Staff Report
 PZ16-00013 (ZC, DEV)
 Village at Saddlerock Crossing
Summary Sheet: Conceptual Review

Meeting Date: September 28, 2017

Action Requested: Conceptual Review of Zone Change and Development Review Application

Project Summary: Conceptual Review of a mixed use project consisting of 126 lodging units (Oxford Suites), 12 condominium units, 5 employee housing units, a restaurant, retail space, a new public road, and associated site improvements and public amenities

CONCEPTUAL LANDSCAPE PLAN
 JULY 2017

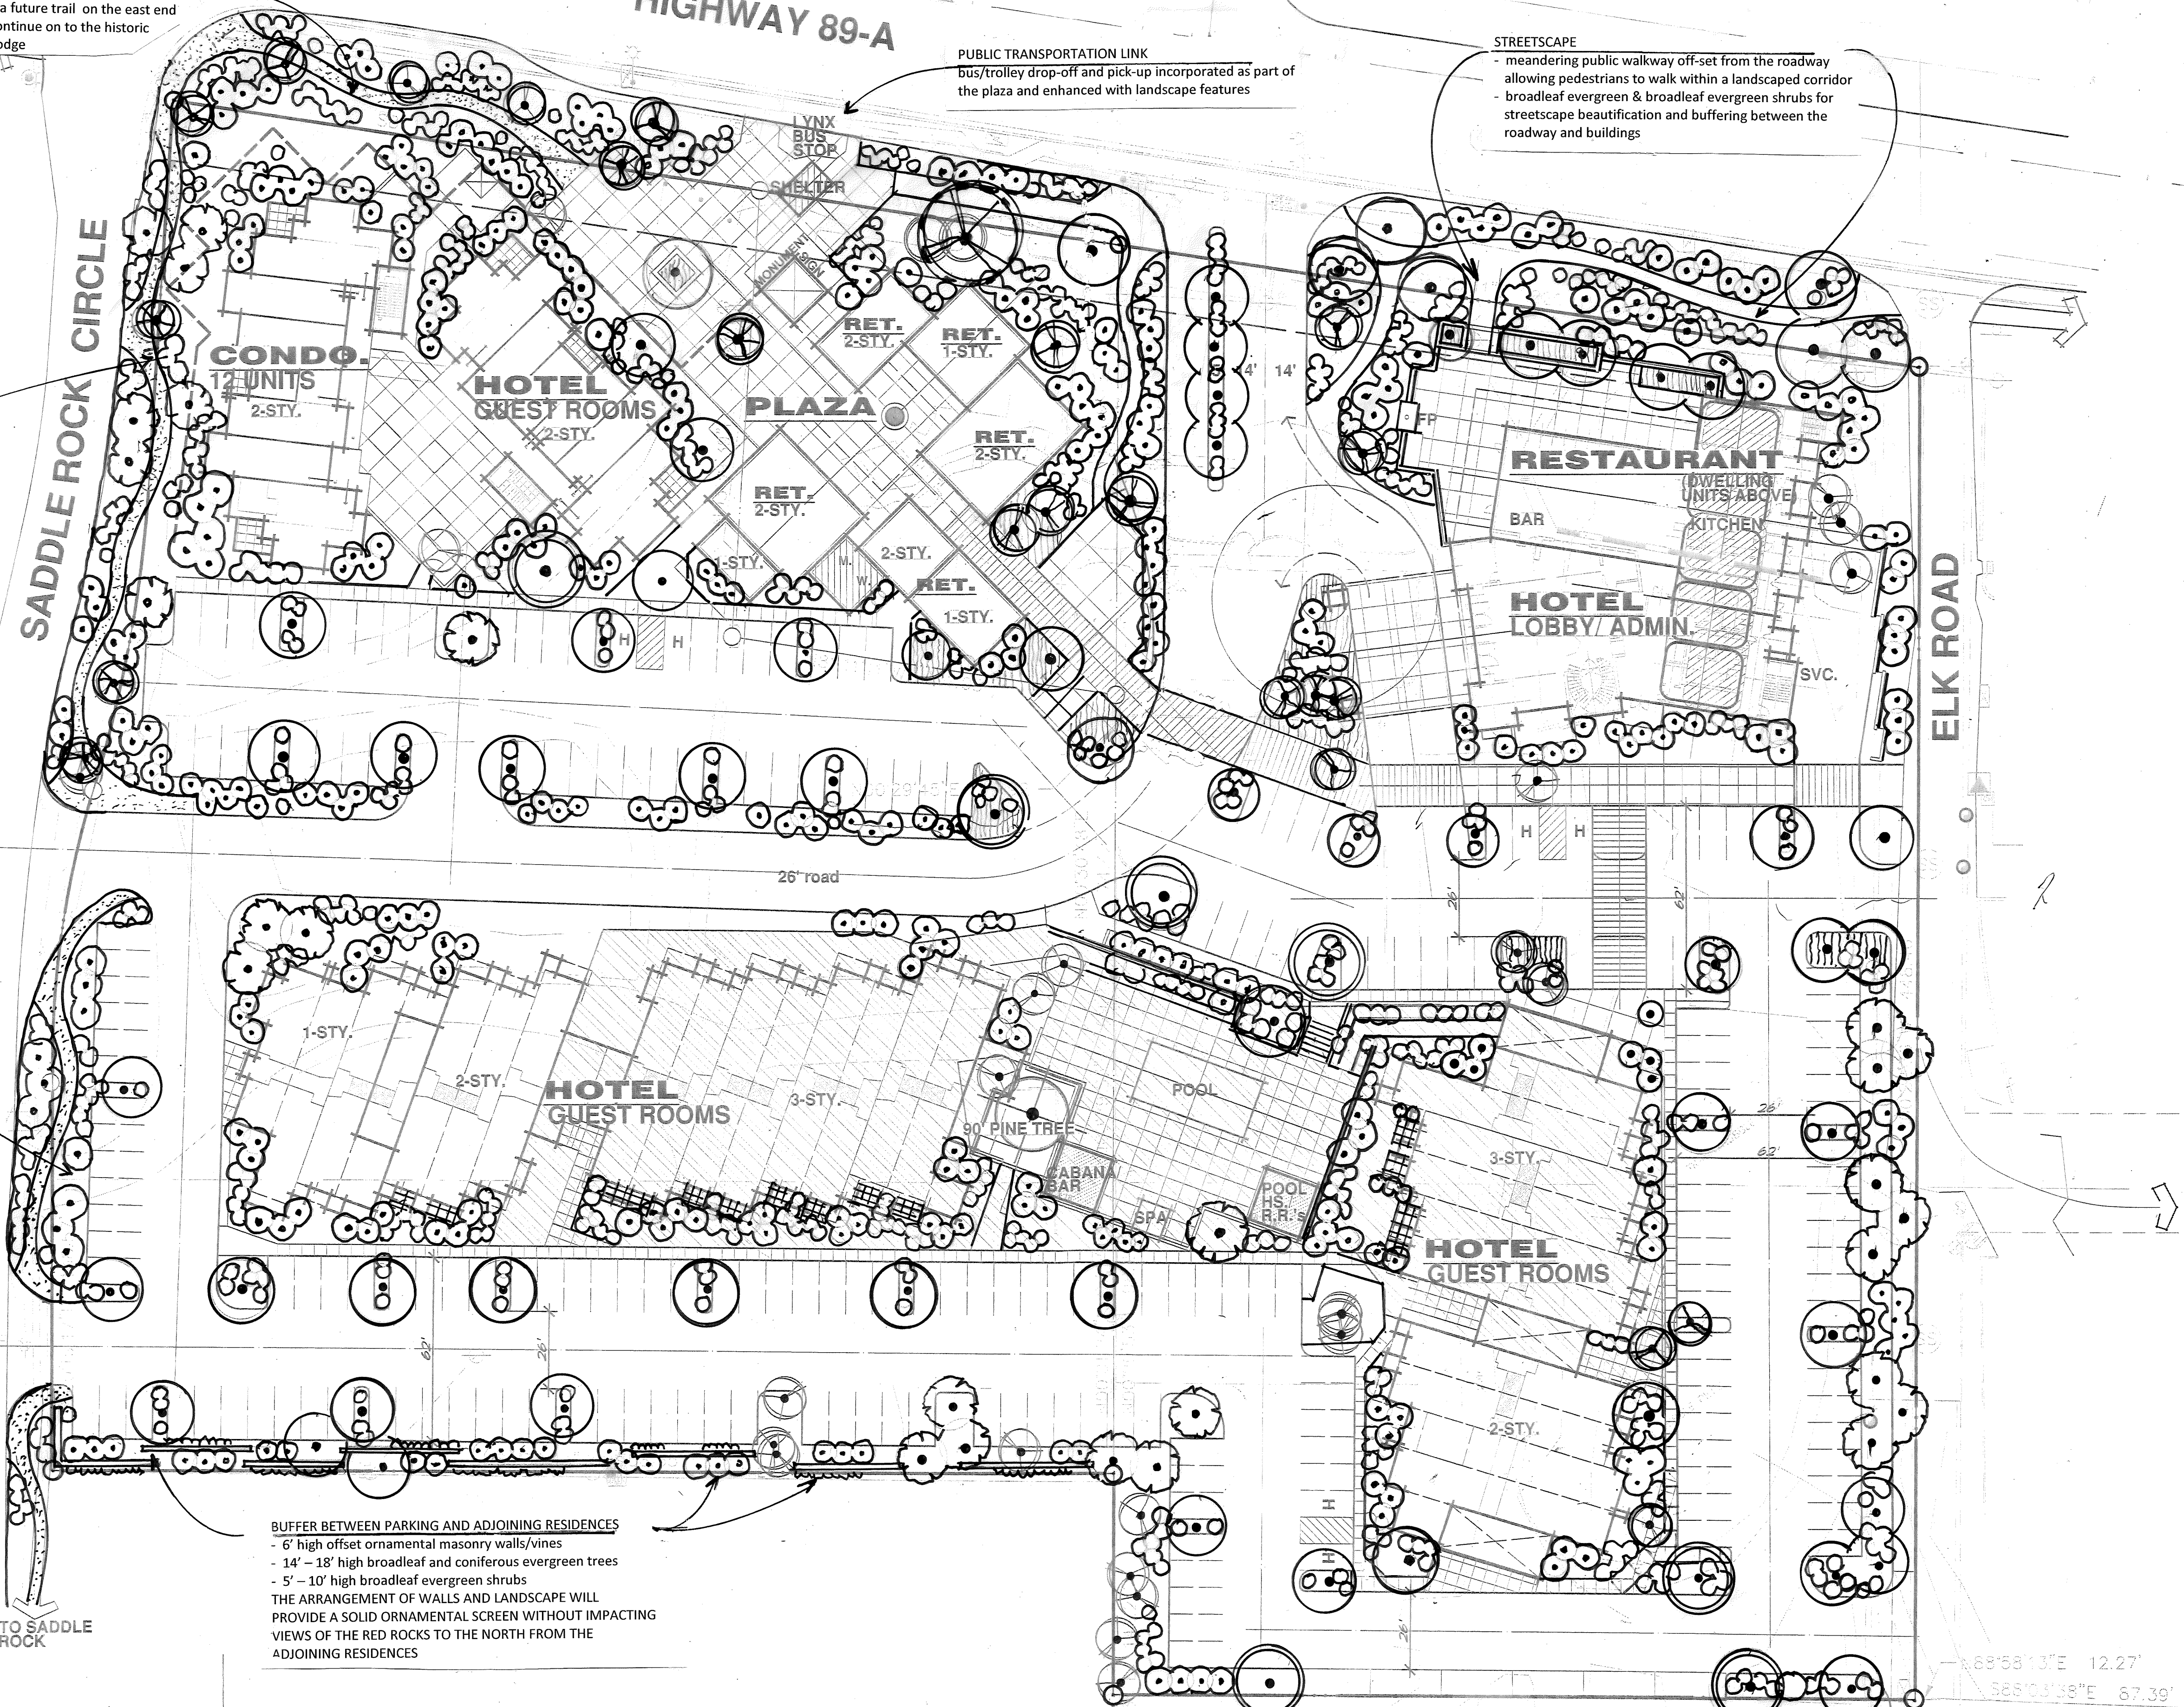
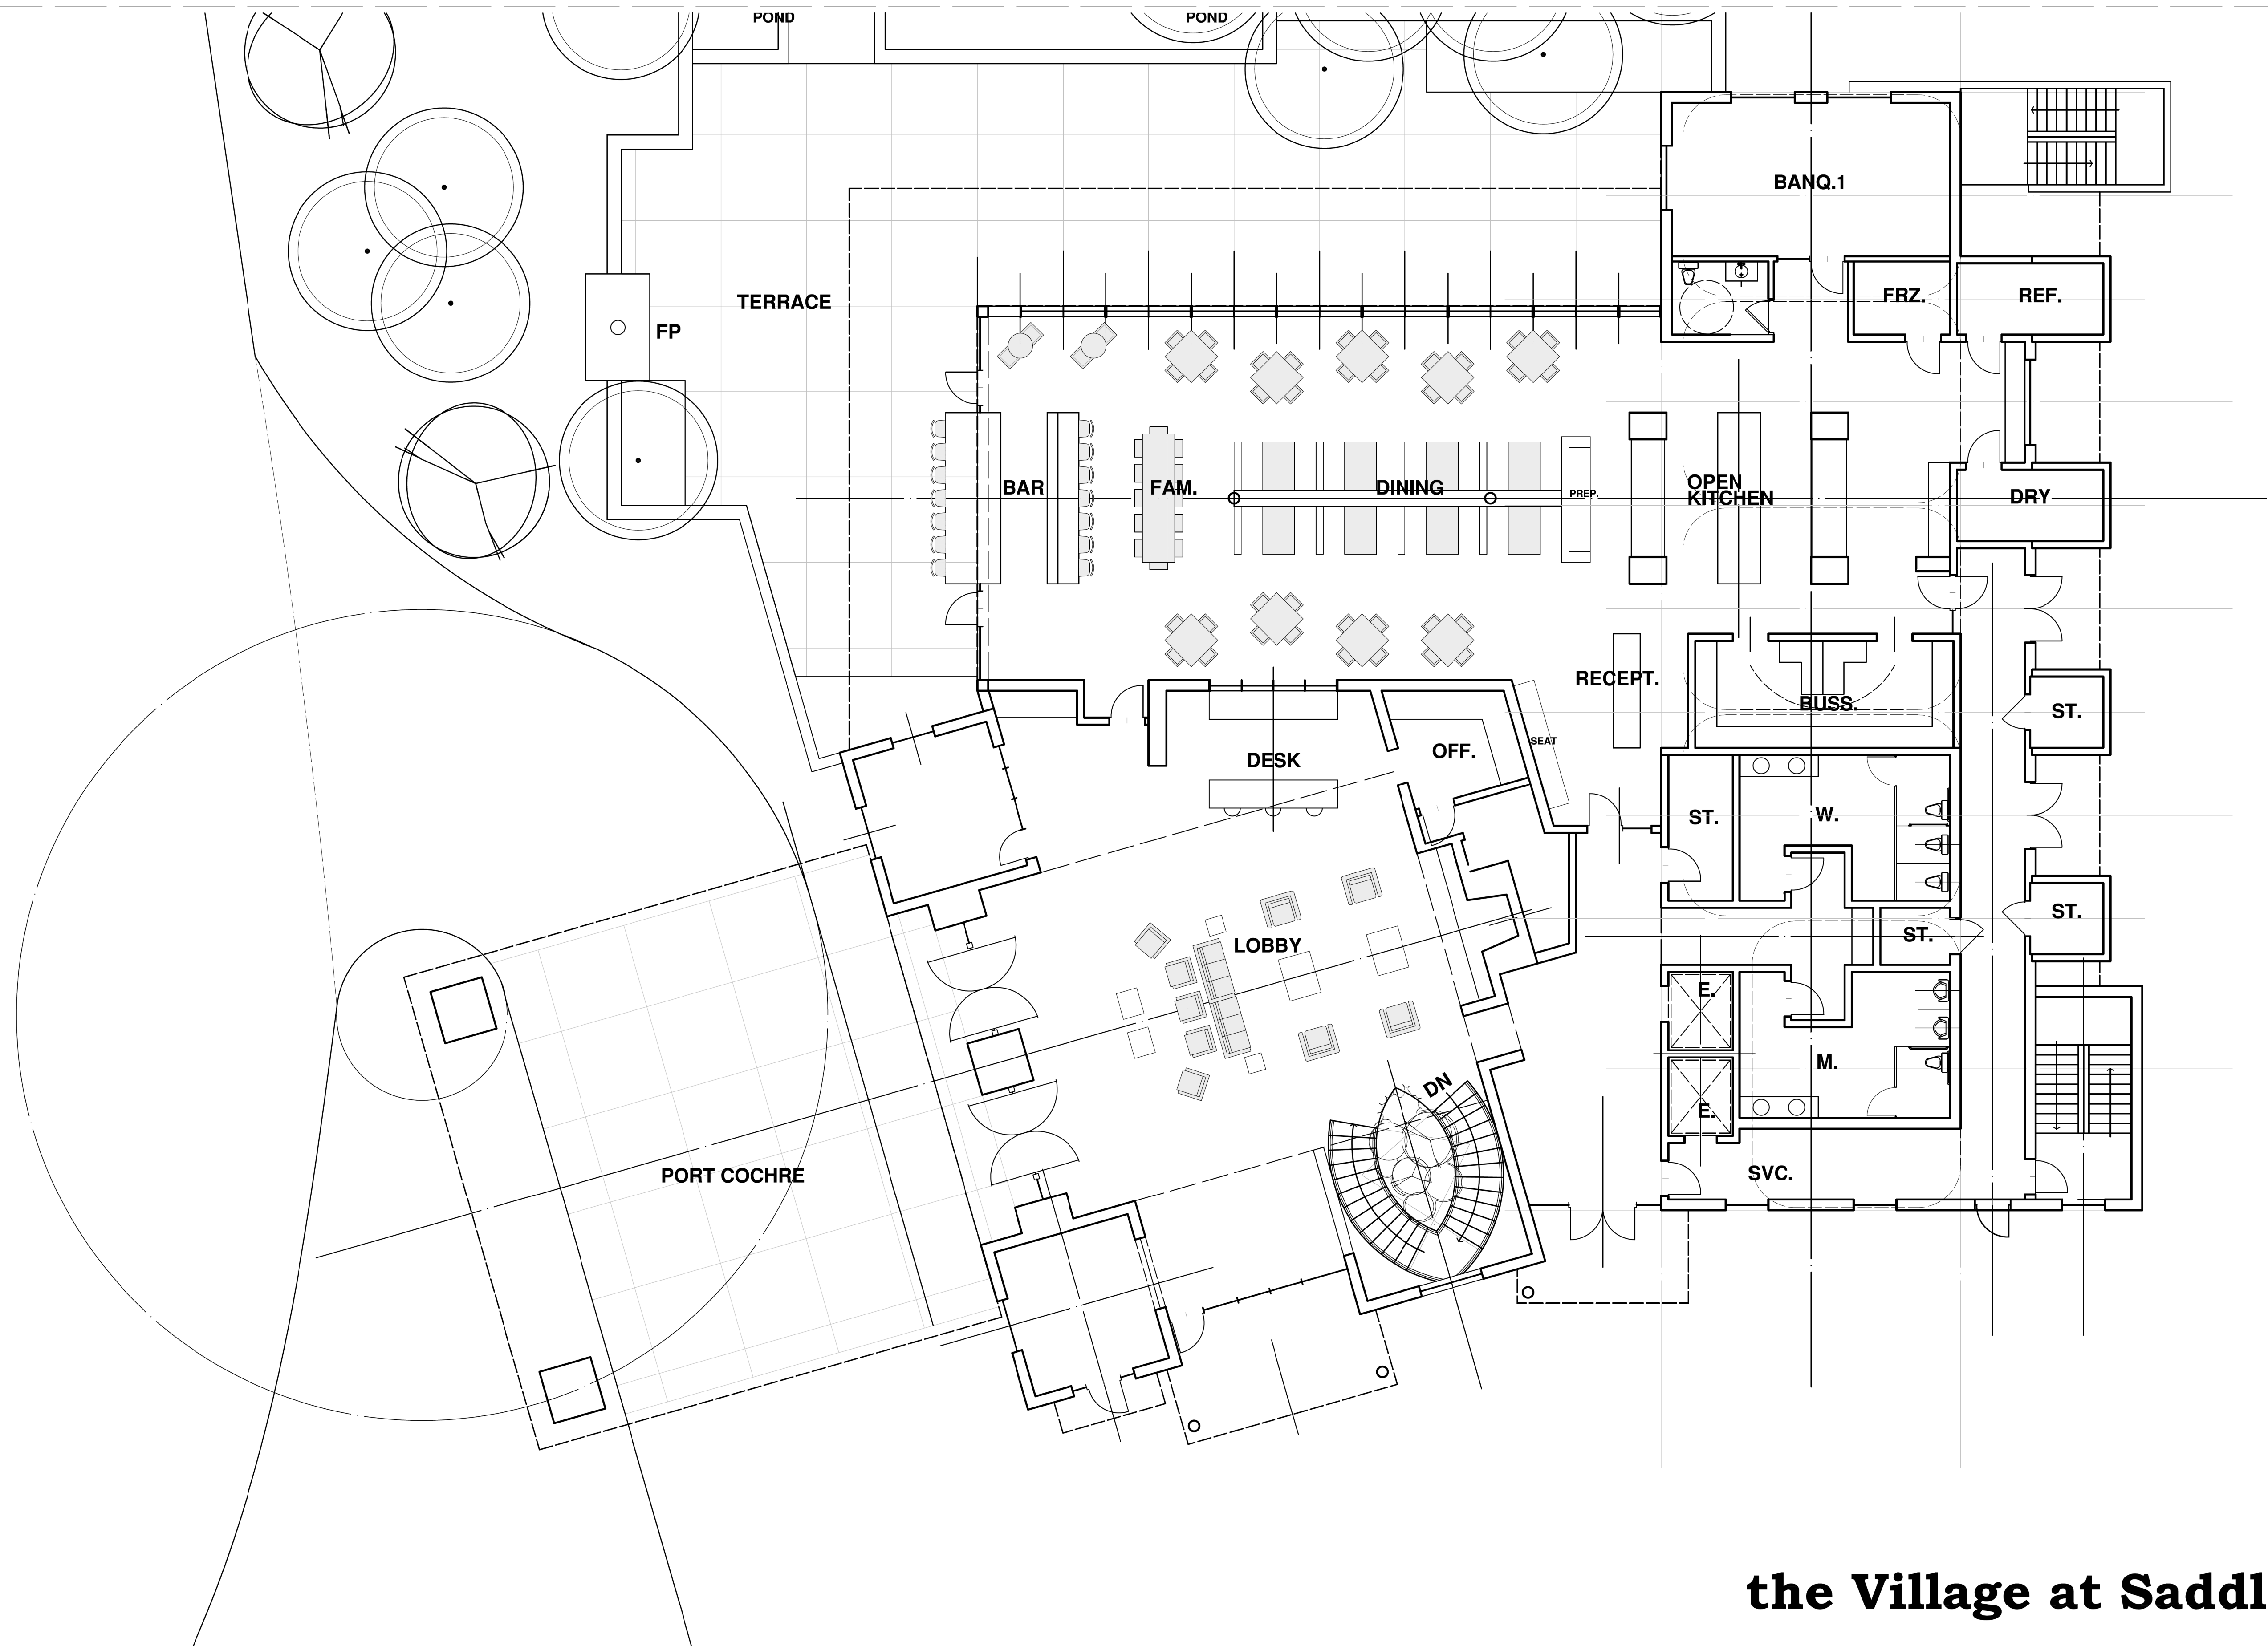
- The applicant has shown proposed landscaping areas on the site plan and submitted a conceptual landscape plan.
- The conceptual landscape plan includes the preservation of some of the existing trees.
- *A comprehensive evaluation for compliance with City landscaping requirements and the applicant's representations will be conducted at the next stage of review*
